# Access Compliance Report

## Public Rights-of-Way

### (Curb Ramps)

Intersection ID: 49251	Main Street: RIDGE_PATH_LN	Cross Street: PROSPERITY_RIDGE_RD	Location: S
ADA ID: 6F67DB9ABC87	Ramp Type: Perp	Initial Pass/Fail: Pass	Overall Compliance: No
Severity Score: 2.75			
Codes/Mitigation Info/Possible Solution		Field Measurements/Component Compliance

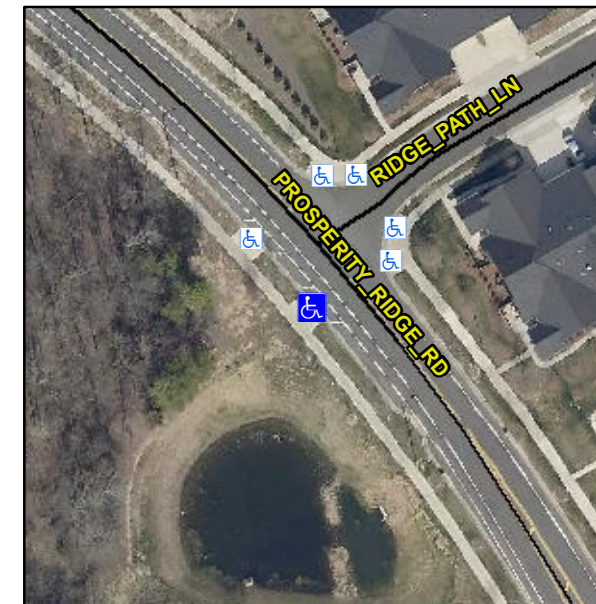
**R304.5.3, R304.2.3**

Compliance	Description	Data	Compliance	Description	Data
N/A	Ramp Length (in)	96.0	Yes	Ramp Slope (%)	8.3
Yes	Ramp Width (in)	48.0	No	Ramp XSlope (%)	2.9
N/A	Flare Type LT	Sloped	N/A	Flare Type RT	N/A
N/A	Flare Slope LT (%)	5.6	No	Flare Slope RT (%)	10.6
N/A	Flare Traversable LT?	Yes	N/A	Flare Traversable RT?	Yes
Yes	Landing Length (in)	71.0	Yes	DWS Provided?	Yes
Yes	Landing Width (in)	48.0	Yes	DWS Contrast?	Yes
Yes	Landing Slope (%)	0.5	Yes	DWS Length (in)	24.0
Yes	Landing X Slope (%)	1.8	Yes	DWS Full Width?	Yes
N/A	Landing Curb? (Y/N)	No	Yes	DWS Offset (in)	0.0
N/A	Shared Landing?	No			
Yes	Gutter Ponding?	No	Yes	Gutter Slope (%)	3.6
Yes	Gutter Lip Ht (in)	0.0	Yes	Gutter X Slope (%)	2.0
N/A	Painted X Walk1?	No	N/A	Painted X Walk2?	N/A
	X Walk 1 Direction	To NE		X Walk 2 Direction	N/A
N/A	X Walk 1 Width (in)	N/A	N/A	X Walk 2 Width (in)	N/A
	X Walk 1 Slope (%)	4.4		X Walk 2 Slope (%)	N/A
	X Walk 1 X Slope (%)	2.6		X Walk 2 X Slope (%)	N/A

**Remove & Replace Entire Ramp.**
